Inconsistency of the Clause 134 OSI model with functional block diagram

Nov 7th, 2016

IEEE 802.3cd Task Force Meeting

Figure 134-1—RS-FEC relationship to the ISO/IEC Open Systems Interconnection (OSI) reference model and the IEEE 802.3 Ethernet model

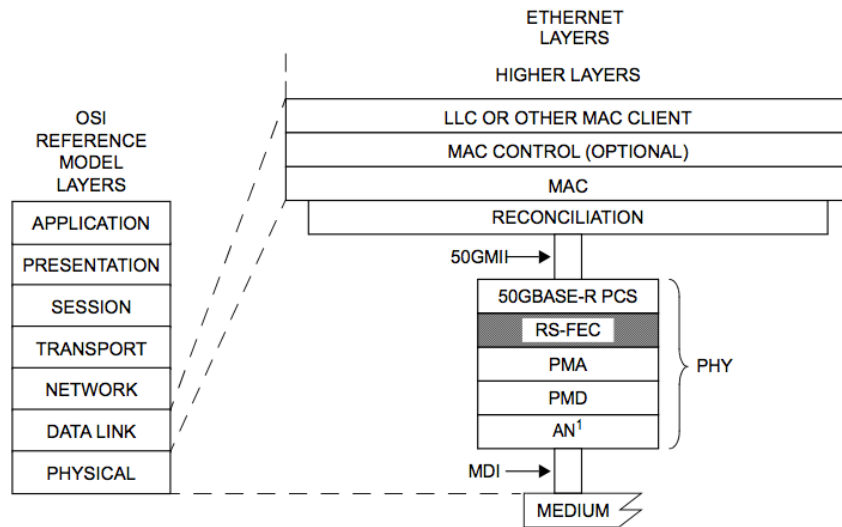
Figure 134-1 show an integrated OSI but Figure 134-2 show the full implementation allowing separate PCS and FEC blocks

Figure 134-2—Functional block diagram

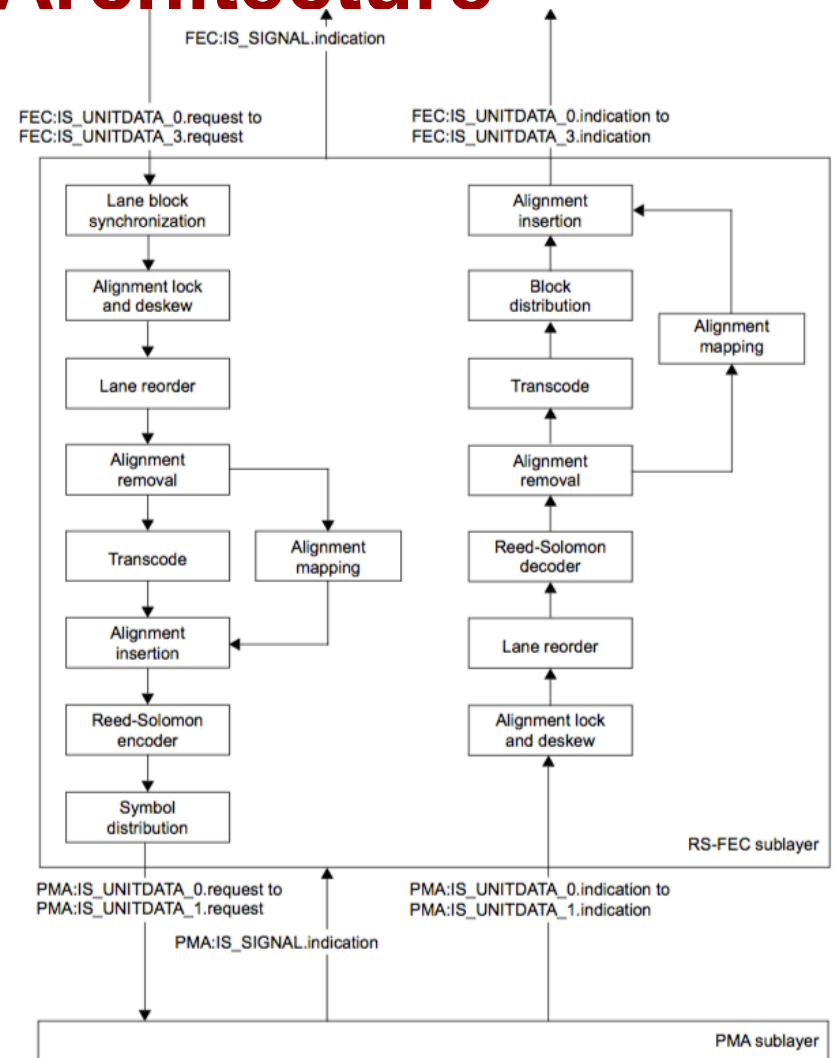
Layering diagram does not capture separate PCS+FEC

Optional PCS functions in integrated solutions

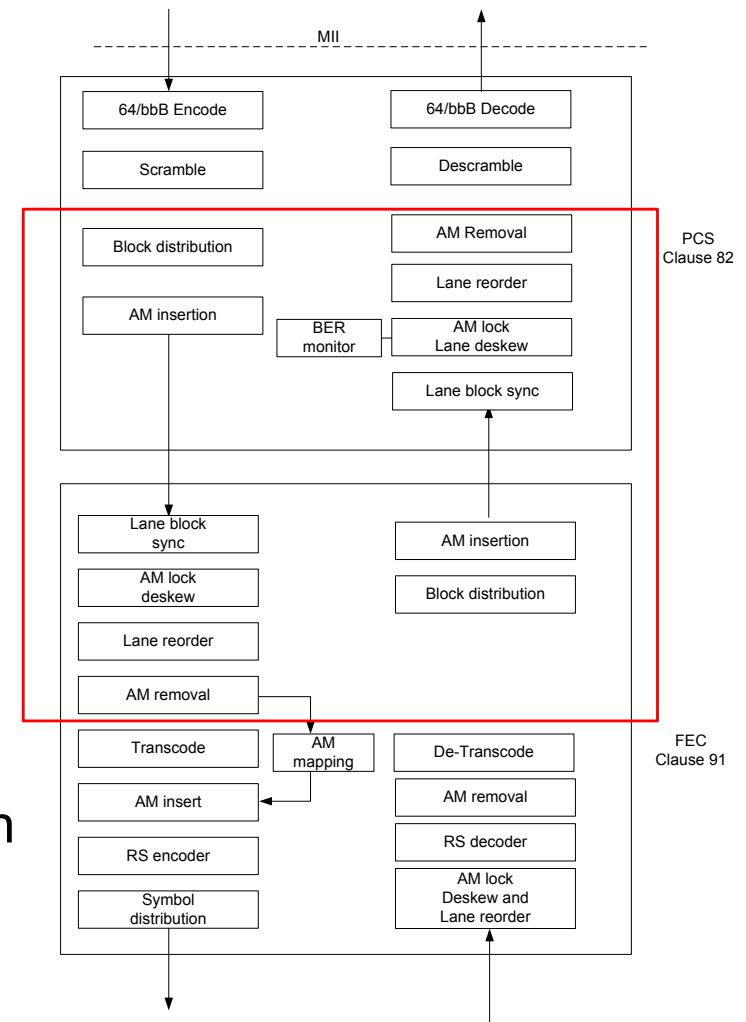
- As described in July meeting presentation, part of PCS/FEC function blocks are redundant in integrated PCS/FEC architecture, like in 802.3bs.
 - *Marked in red rectangle.*
- Skipping these blocks in real implementation save power and latency, and thus preferable.
- This contribution aims to provide some options how to write the PCS clause when PCS and FEC are separated as well as when PCS and FEC are integrated.
